STAFF REPORT

HEARING 11/17/2020 Legend DATE: Project Location TO: Mayor & City Council ru t R-8 FROM: Sonya Allen, Associate Planner C-C 208-884-5533 C-C L-O C-N c-c SUBJECT: FP-2020-0004 R-15 Linder Village LOCATION: Southeast corner of N. Linder Rd. and W. R-4 Chinden Blvd./SH 20-26, in the NW 1/4 L-O R-8 of Section 25, Township 4N., Range RUT 1W.

Final plat consisting of 19 buildable lots (17 commercial and 2 residential) on 74.89 acres of land in the R-8 and C-C zoning districts.

B. Final Plat (dated: 10/19/20)

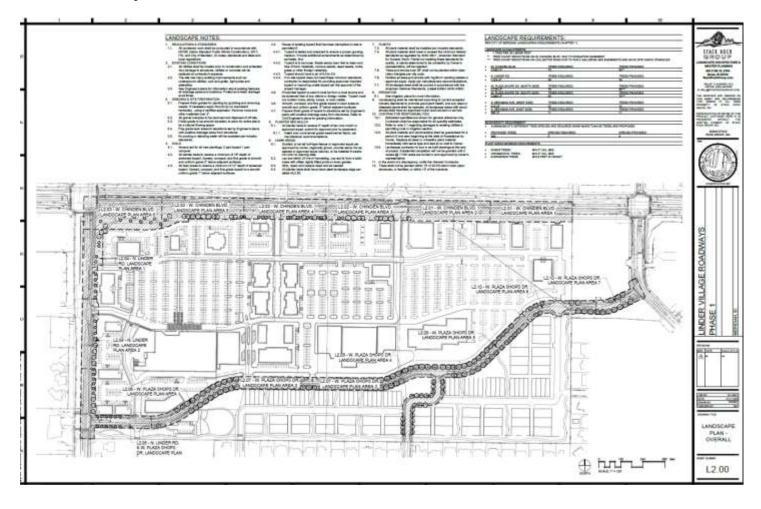
- 3. Prior to submittal for the City Engineer's signature, have the Certificate of Owners and the accompanying acknowledgement signed and notarized.
- 4. The final plat prepared by Fox Land Surveys, stamped by Timothy J. Fox, dated: 10/19/2020, included in Section V.B shall be revised as follows:

- a. The line type depicted in the Legend for the plat boundary is used in other areas that are actually lot lines, not the plat boundary; revise accordingly.

- b. Legend: Include the recorded instrument number for the sewer and water easement on Sheets 1, 2 and 3.
 - c. Include the ITD Right-of-Way Instrument number on Sheets 1 and 3.

- d. Include the sidewalk easement number in Detail "A" on Sheet 2 and on Sheet 3.
 - e. Include the permanent ACHD easement in Details "A", "B" and "A-2" on Sheet 2 and on Sheet 3.

- f. Include the recorded instrument number for N. Bergman Avenue on Sheet 3.
 - g. Include the recorded instrument number for the 20' wide Winco water main easement depicted on Lot 2, Block 1 on Sheet 3.

- h. Include the recorded instrument number for the private 20' wide sewer easement depicted on Lot 15, Block 1 on Sheet 3.
 - i. Plat Note #3: "No lots shall be reduced in size without prior approval from the health authority and the City of Meridian."

- j. Plat Note #9: Include the Settler's Irrigation District recorded license agreement instrument number.
 - k. Plat Note #11: Include the ACHD recorded license agreement instrument number.

- 1. Include a note granting a blanket cross-access/ingress-egress easement between all commercial lots in the subdivision.
 - m. The required street buffers (i.e. 35' along W. Chinden Blvd./SH 20-26, 25' along N. Linder Rd. and 20' along W. Plaza Shops Dr.) shall be depicted on a common lot or a permanent dedicated buffer, maintained by the property owner or business owners' association as set forth in UDC 11-3B-7C.2b.

- n. Graphically depict the location of the cross-access/ingress-egress easement to the south to Parcel #R1034570040 (5968 N. Linder Rd.) & #R1034570020 (5984 N. Linder Rd.) with a note referencing the recorded instrument number of the easement (i.e. Inst. #2020-153916).
